CLEARVIEW EYE CLINIC

EDG#2 MEETING September 4th, 2014

DPD PROJECT #3017306 | DPD PERMIT #TBD | 7520 35TH AVENUE SW | EARLY DESIGN GUIDANCE SUBMITTAL | 9.04.2014

Response to Design Review Boards recommendations / comments from the EDG #1 meeting:

ALTERNATIVE #2: What we heard...

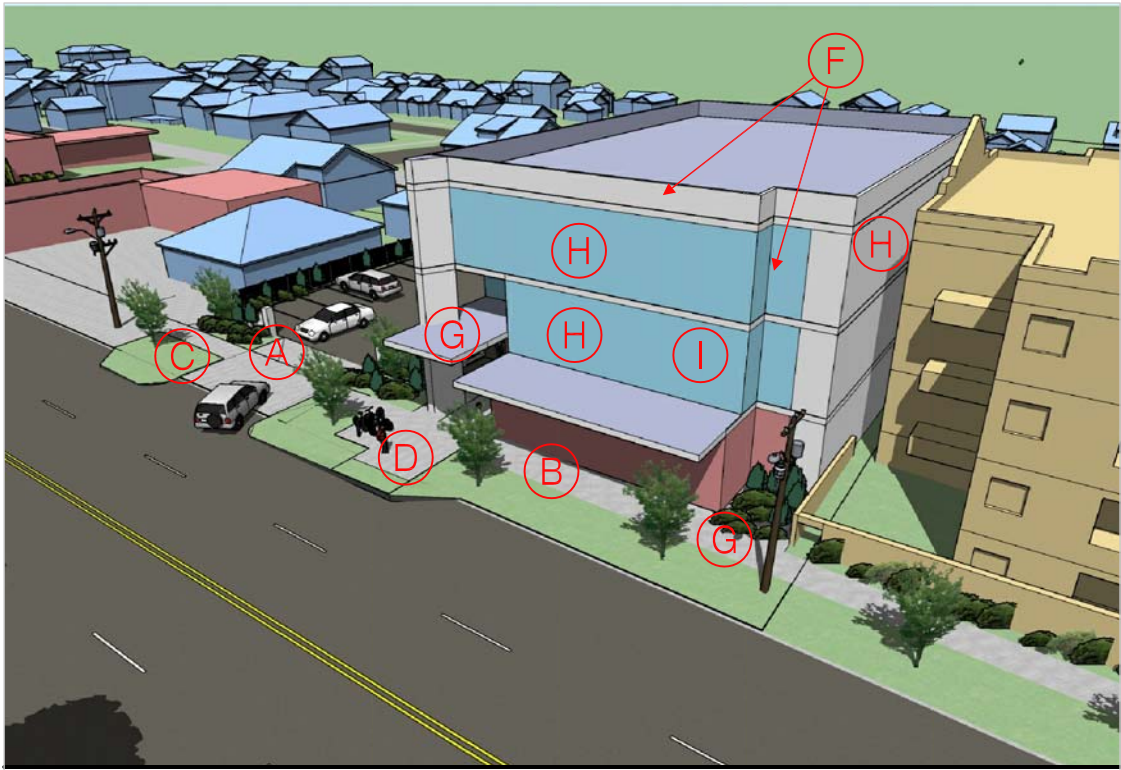
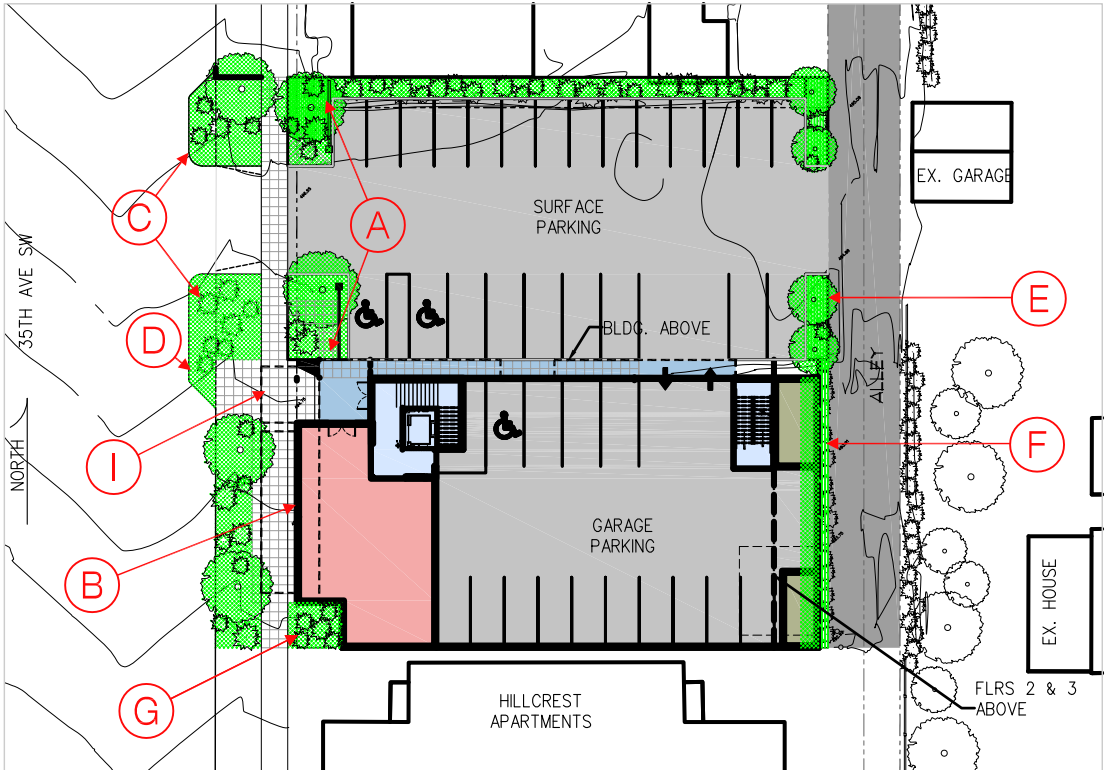
- a. Alternatives 2 and 4 were recommended to further develop.
- b. Alternative # 2 Recommendations and comments by the Board:
Activate the street façade along 35th Avenue SW.
Emphasize design treatment that screens parking.
Alternative may result in additional blank wall façade along 35th Avenue SW.
- c. Alternative #4 Recommendations and comments by the Board:
Design treatment opportunity for the blank walls necessitated by Eye Clinic's programmatic issues.
Provide treatment of parking/landscaping to minimize the visual impact and architectural engagement along 35th Avenue SW frontage.

f. The applicant is to explore massing that meets programmatic needs for the Eye Clinic which includes possible fenestration and other articulation treatments with particular emphasis on the northern and western facades that face 35th Avenue SW. (DC2.A and B)

- A Screening Parking on 35th Ave SW
Proposed building wall & setbacks allow for landscaping to screen parking from 35th Ave SW
- B Commercial Frontage on 35th Ave SW
Approximately one-half of 1st level will have blank walls and garage entry facing 35th Ave SW. Less than one-half will be commercial frontage. Semi-enclosed garage presents safety and access issues.
- C Landscaped Bulbs in R.O.W.
Bulbs are proposed projecting into curb parking to eliminate cars from parking too close to curb cut, and cutting off sight lines for turning.
- D Landscaped Bulbs At Main Entry
Proposed bulbs will be landscaped and the south bulb will enhance the building main entry.

- E Landscaping & Fence At Alley
6' high fence with landscaping adjacent screens surface parking from residential zone.
- F Facade Modulation & Blank Walls
Modulation on west and east facades will reduce the visual scale of the building. North and south walls are blank walls.
- G Interior Requirements/Space Plan
2nd floor contains approximately 3000 sf of exam rooms, procedure suites and support space that does not function with windows.

- H. Fenestration
North and south walls will not have fenestration. East wall will have approximately 1/3 of wall area available for fenestration. West wall will have approximately 1/2 of wall in fenestration.
- I Side Walk on 35th Ave SW
Widened at commercial and main entry.

MASSING COMPARISON - ALTERNATIVE #4; (PREFERRED)

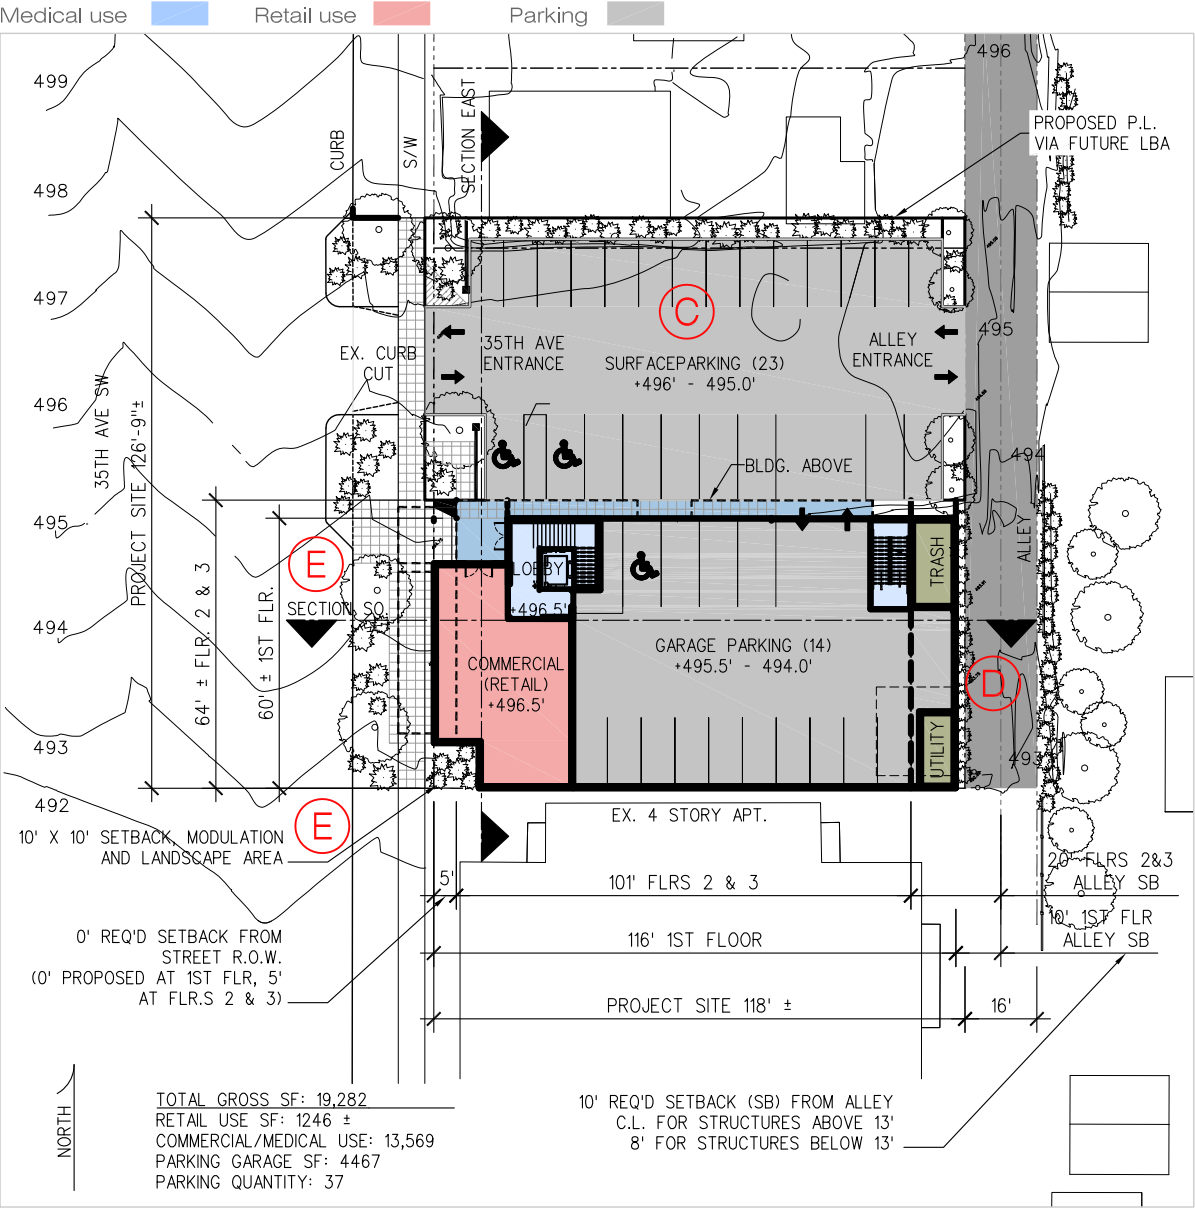
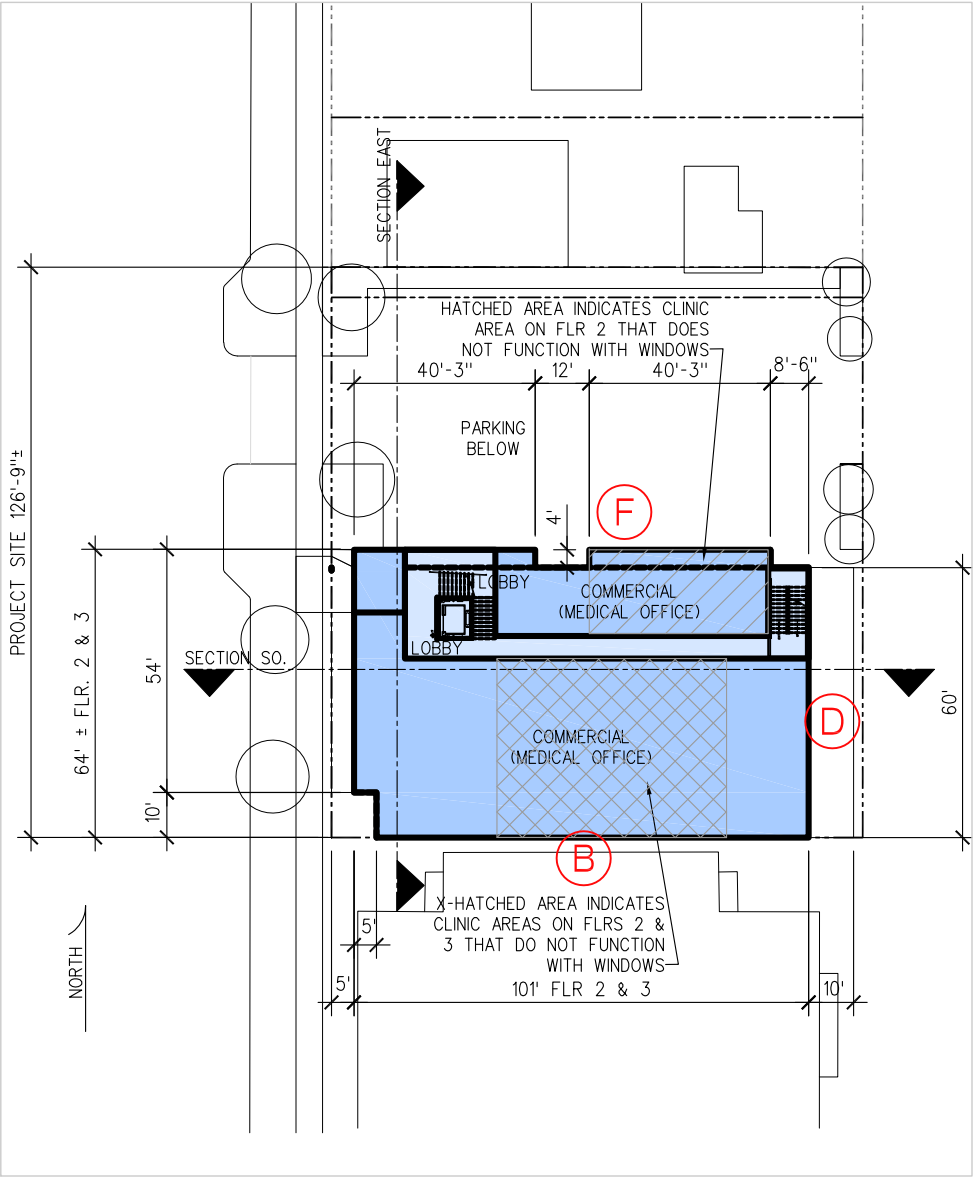
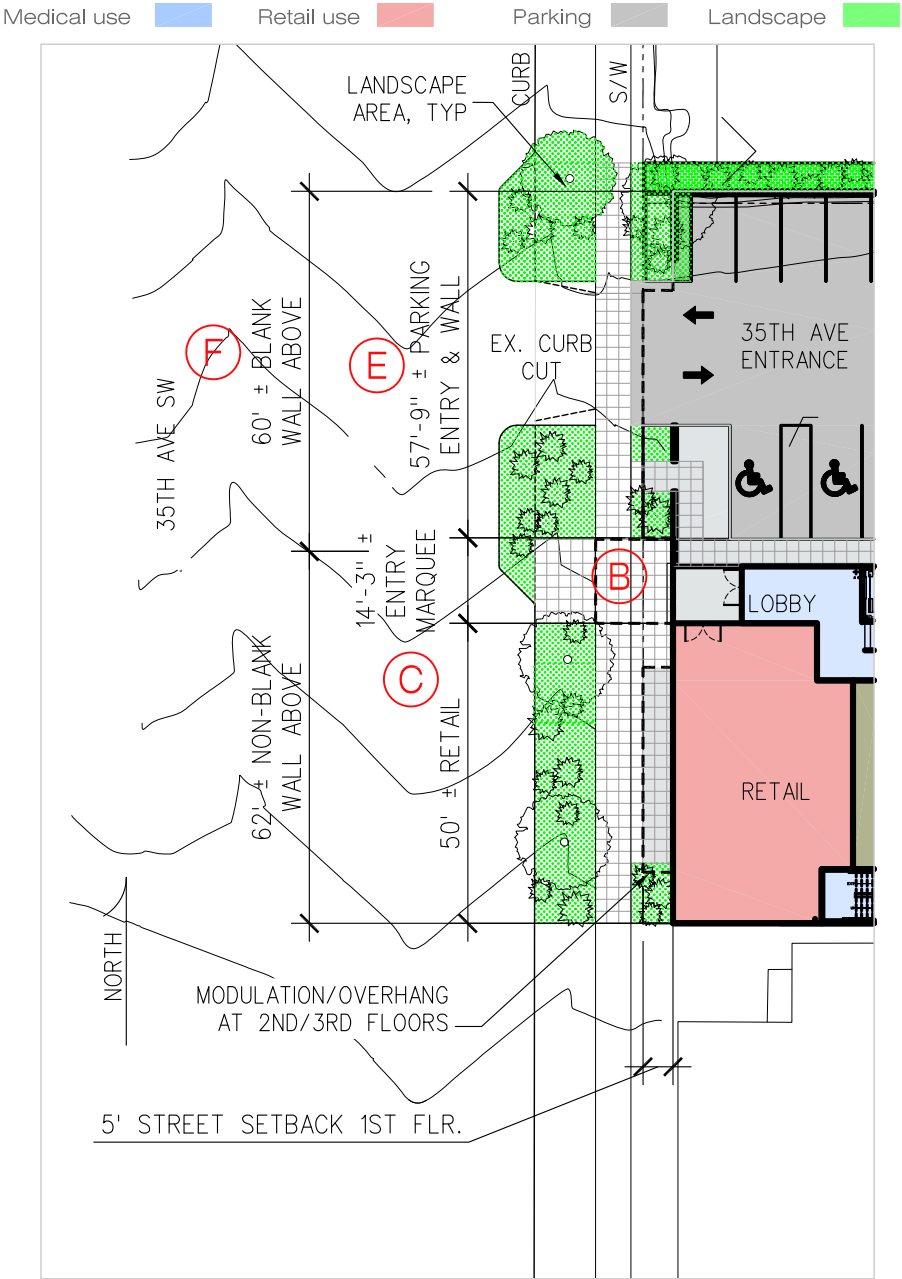
a. Board appreciated that Option #2 minimized potential solar impacts on the eastern adjacent residential zoned properties.
Response: Option #4 (preferred) has set backs from the alley which will help mitigate solar impact on the eastern adjacent zoned residential properties.

b. Board encouraged further evaluation of massing configurations and design treatments that may dissipate the perceived height, bulk and scale in relation to the residential zoning to the east. (CS2.C)
Response: Both alternatives presented have modulation and fenestration indicated relative to the residential zoning .

- A Height of building matches height of Hillcrest Apts.
- B South wall on property line has no openings. East, North and West walls will have fenestration. East & West walls can have maximum fenestration on the upper two walls that relate to the clinic's function.
- C Surface parking extending from 35th Ave SW to alley provides an open air break at roughly mid-block in a 600' long block from SW Webster St to SW Holden St.
- D Building facade at alley is proposed to be stepped back, allowing more sunlight to fall on neighboring residential zone in the winter. The stepping will also allow for

landscaping and deck at second level. The step provides for more visual privacy for the residential zone to the east and visually breaks down the mass of the building.

- E 35th Ave SW facade is modulated vertically and horizontally. Commercial frontage proposed at property line with the upper two floors set back 5' from street property line. This setback aligns with the Hillcrest apartments main facade. Southwest corner of building is cut away and landscaped. Main entry is recessed from sidewalk with a generous marquee highlighting the entry. The commercial frontage will have a weather protection canopy at storefront.
- F North Facade is modulated and allows for partial fenestration based on clinic's interior program.
